Faith Fellowship Assembly of God

Staff Report for the September 4, 2002 Development Review Committee Meeting

**Agency Review Comments for
SP-95-02 Faith Fellowship Assembly of God**

ENVIRONMENTAL DIVISION REVIEW COMMENTS
FAITH FELLOWSHIP ASSEMBLY OF GOD
COUNTY PLAN NO. SP - 095 - 02
August 27, 2002

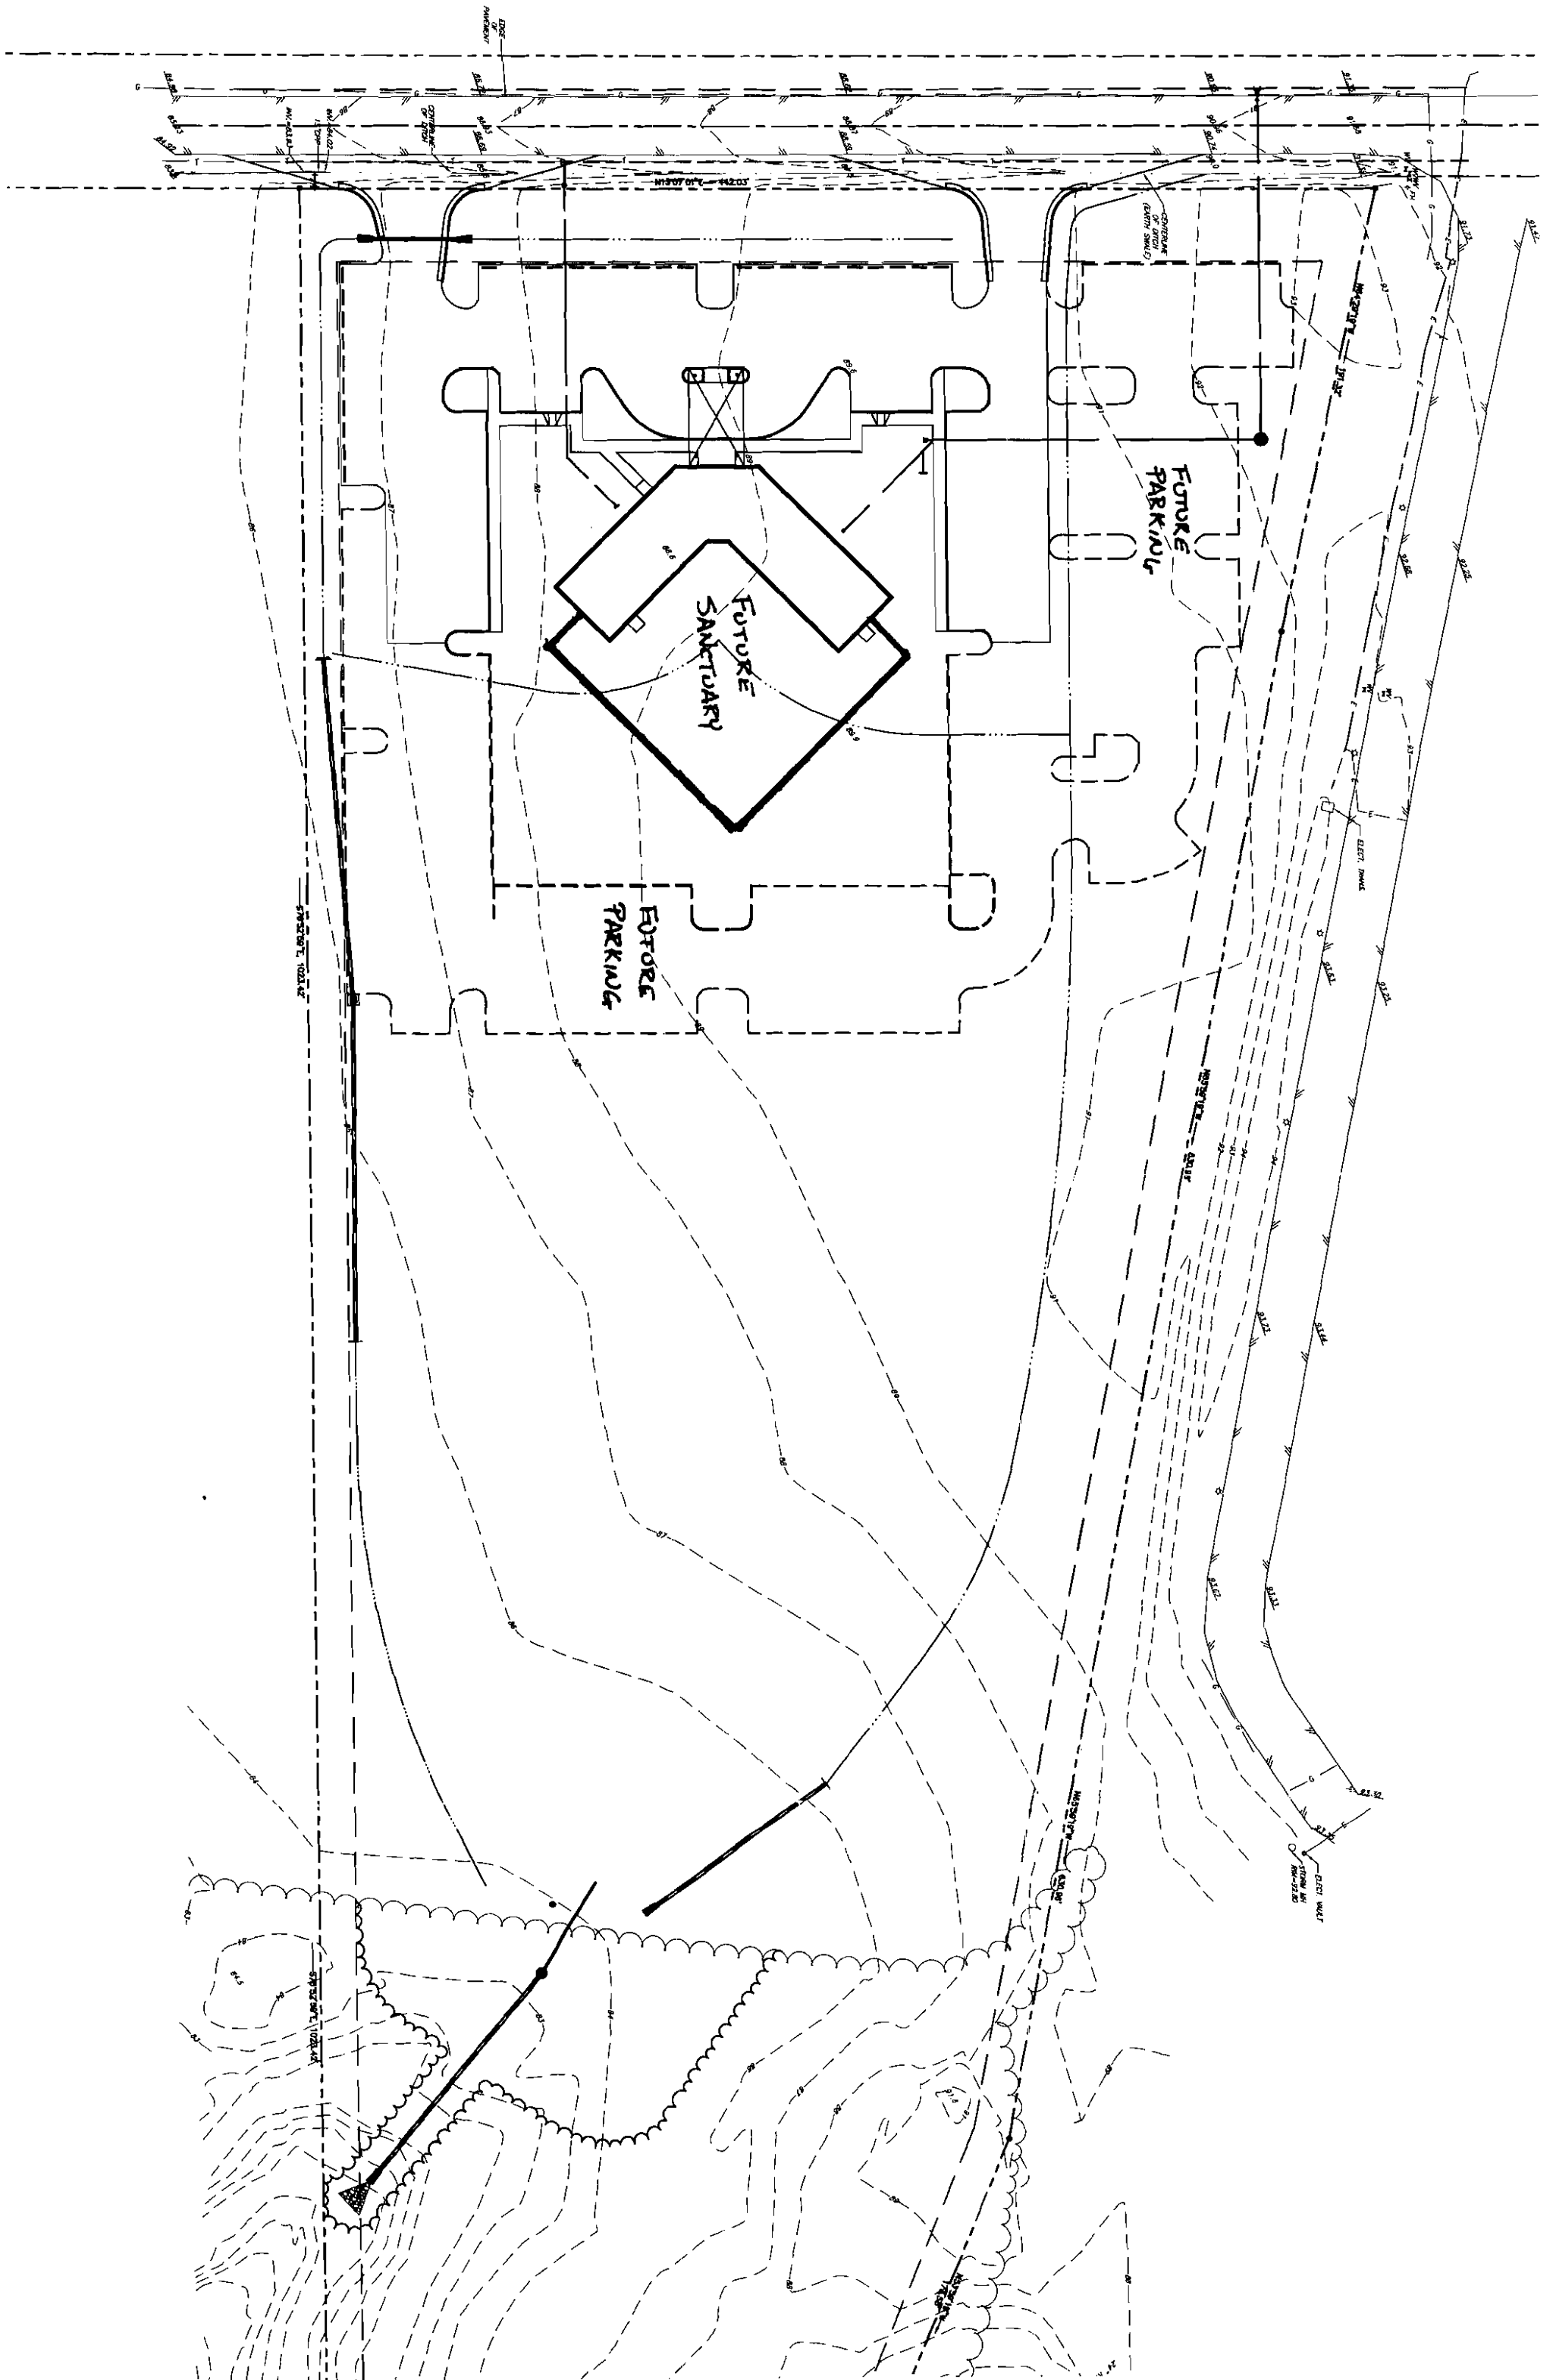
Our reasoning behind the two (2) entrances is as follows:

1. The future parking of the site will be wrapped around the building and will require two (2) entrances.
2. The two (2) entrances to the site allows for better site circulation now, particularly for elderly drop-off at the entrance.
3. The site is located on a dead-end street with fixed vehicular generation from our proposed entrances to the end of the street. In addition, the two (2) entrances are directly across from the proposed ball fields for Williamsburg Christian Academy; thus, creating no potential for conflict with ingress and egress to that site.
4. Traffic for this site will be at times where there is no anticipated traffic for the two educational facilities; thus, creating no conflicts with additional vehicles on the roadway.
